REQUEST

Current Zoning: N1-A (neighborhood 1-A)
Proposed Zoning: N1-F(CD) (neighborhood 1-F, conditional)

The petition proposes to develop two triplex buildings and one quadplex on two parcels currently developed with two single family detached homes.

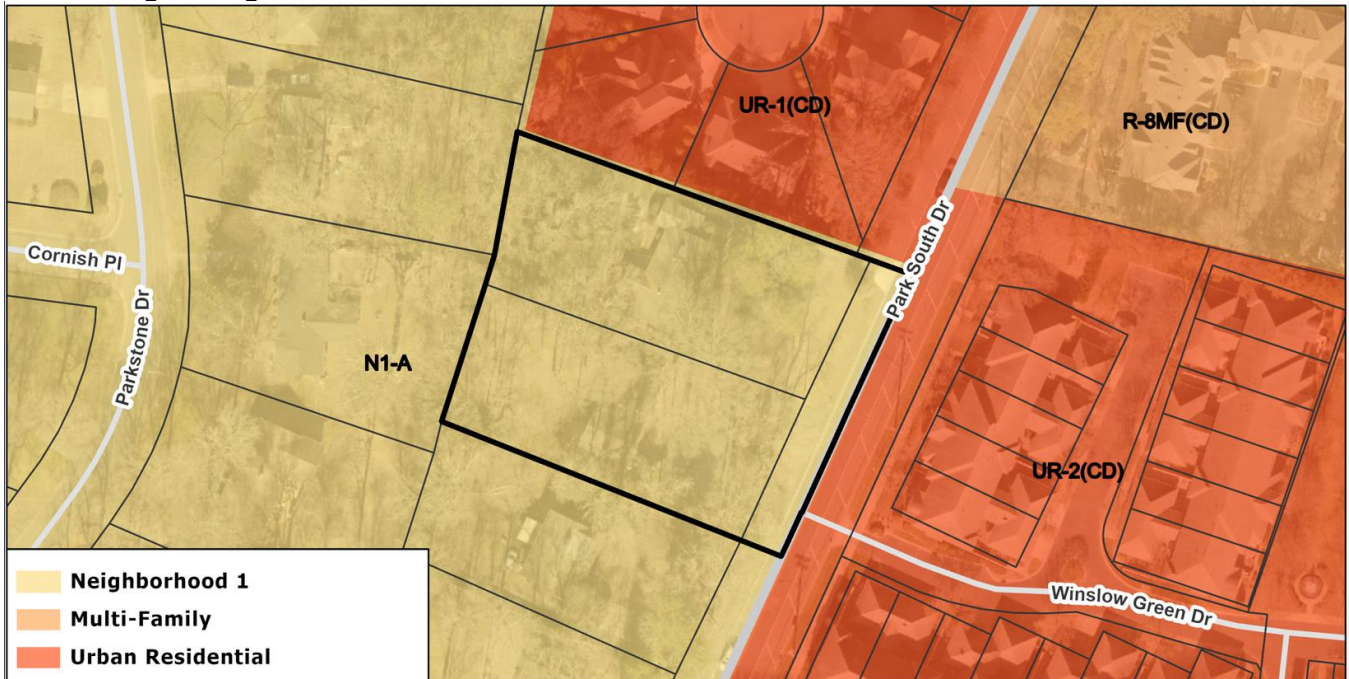
1. ~~Revise the proposed driveways for the individual units to be compliant with Article 19.6.A.1.a of the UDO.~~ **Addressed**

2. ~~Clarify if the tree save area shown on the site plan is outside of the demolition plan.~~ **Addressed**
3. ~~The replanted tree save area will have to be at a higher rate than the required minimum of 15% of the site. Increase the proposed tree save on the plan.~~ **Addressed**

4. ~~The dimension for the proposed back of curb to the center line must be shown on the site plan as well as the buffered bike lane that is required per the Charlotte Streets Map cross section.~~ **Addressed**
